1989 Ford Truck F 250 4WD Pickup V8-445 7.3L DSL

M/T - Clutch Fluid Leaks/Incomplete Release

Article No. 90-16-7

^ CRACKS - DASH (ENGINE COMPARTMENT BULKHEAD) - [CLUTCH MASTER CYLINDER AREA](#) - VEHICLES BUILT BEFORE 6/15/90

Figure 4

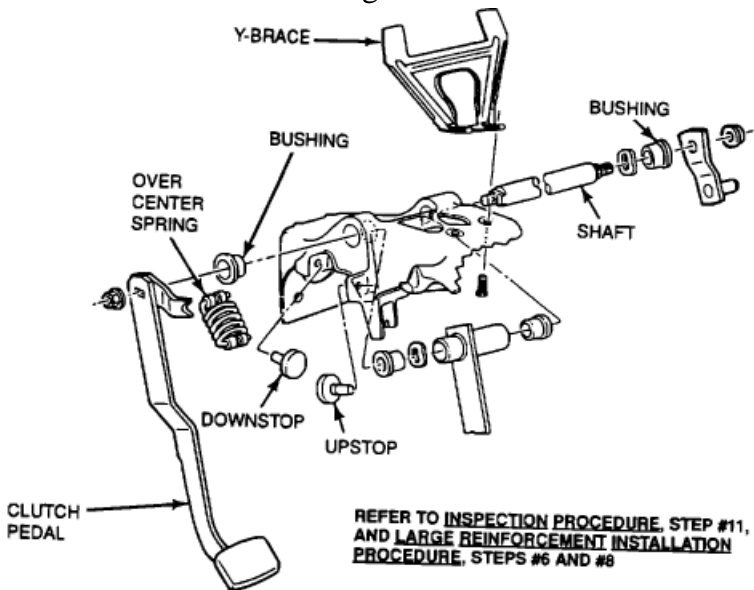
- c. Look for the dash reinforcement moving away from the dash, Figure 3.
 - d. On 1987 and earlier models, look down inside the cowl cover at the cowl where it is attached to the dash reinforcement. Check for pulled spot welds.
11. If there is significant movement of the dash or [clutch master cylinder](#), proceed as follows:
- a. Remove the steering column and its dash toe plate and seal. Refer to the appropriate Light Truck Shop Manual, Section 13-07 for service details.
 - b. Inspect the dash inside the cab and look for:
 - ^ Pulled spotwelds and cracked or torn sheet metal.
 - ^ Cracks in the brake and clutch pedal support

^ Missing Y-brace fasteners and a broken or detached Y-brace, Figure 4.

Figure 5

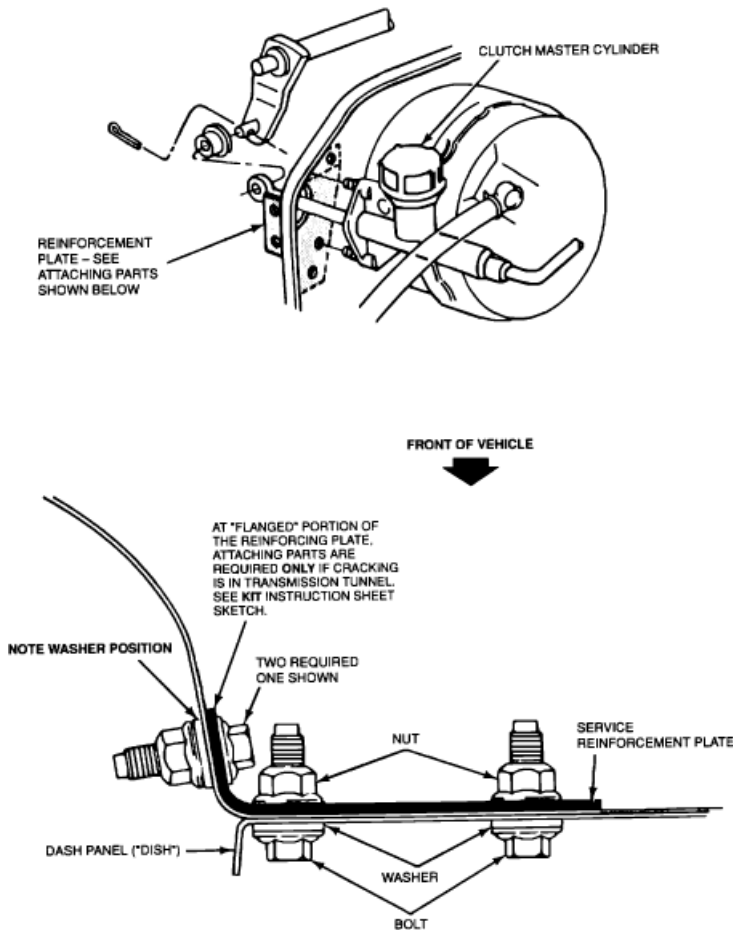
There are two small reinforcement kits. One for 1988 and later models and one for 1987 and prior models. This is necessary because a new hydraulic [clutch master cylinder](#) mounting pattern was introduced for 1988 models.

Use reinforcement kit E3TZ-7K509-A on these trucks, Figure 5. Comprehensive installation instructions are included in this kit.

Figure 6

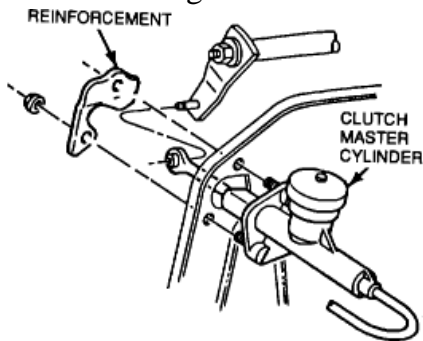
Use reinforcement kit E8TZ-7K509-A on these trucks. The only part in this kit is the special reinforcement for these trucks. To install it, proceed as follows:

1. Remove the two [clutch master cylinder](#) attaching nuts (13 mm) from inside the truck.
2. Position the reinforcement in place over the [clutch master cylinder](#) studs.
3. Re-install the two master cylinder nuts, Figure
6. Tighten to 9.5 - 14.9 N-m.

Figure 7

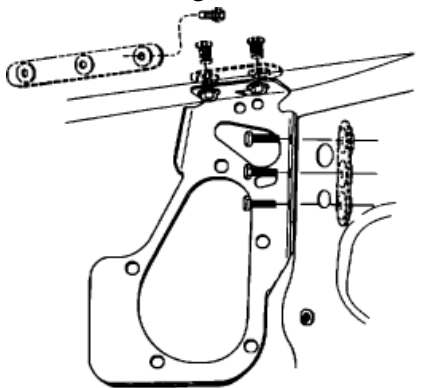
Use reinforcement kit E3TZ-7K509-B on all 1983-1991 Bronco/F-Series trucks with hydraulic clutch controls. The kit consists of the following items:

One plate helps attach the main doubler through the dash inner tunnel. The other large piece is placed inside the front of the cowl, with bolts driven through from the engine compartment side of the dash reinforcement, see Figure 7.

Figure 8

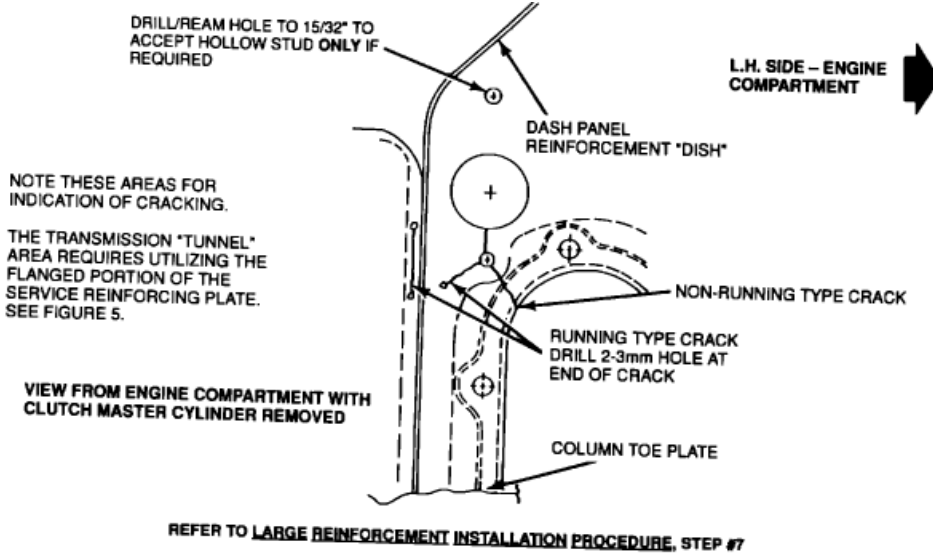
- c. Loosen the two (2) fasteners attaching the brake and clutch pedal support to the Y-brace, Figure 4.
7. Check for cracks.
 - a. Pull back the floor covering and dash sound insulator. (it may be helpful to remove the accelerator pedal.)
 - b. Inspect the area for pulled welds and torn dash sheet metal.

- c. If there are cracks that have not run out, stop them by drilling a 2-3 mm hole at the end, Figure 8.
NOTE: WELDING OR BRAZING IS NOT RECOMMENDED, BECAUSE IT COULD BE A SOURCE OF FUTURE BLIND SIDE CORROSION.

Figure 9

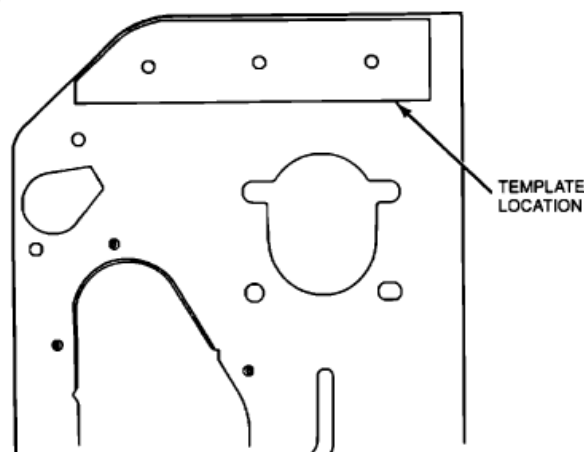
- d. Attach two 8 mm nuts from the inside of the cab.
14. Using the paper template provided in the kit, proceed as follows:

- a. Center punch and drill three 3/8" (9.5 mm) holes into the dash reinforcement and through the cowl, from the engine compartment side, Figure 9.
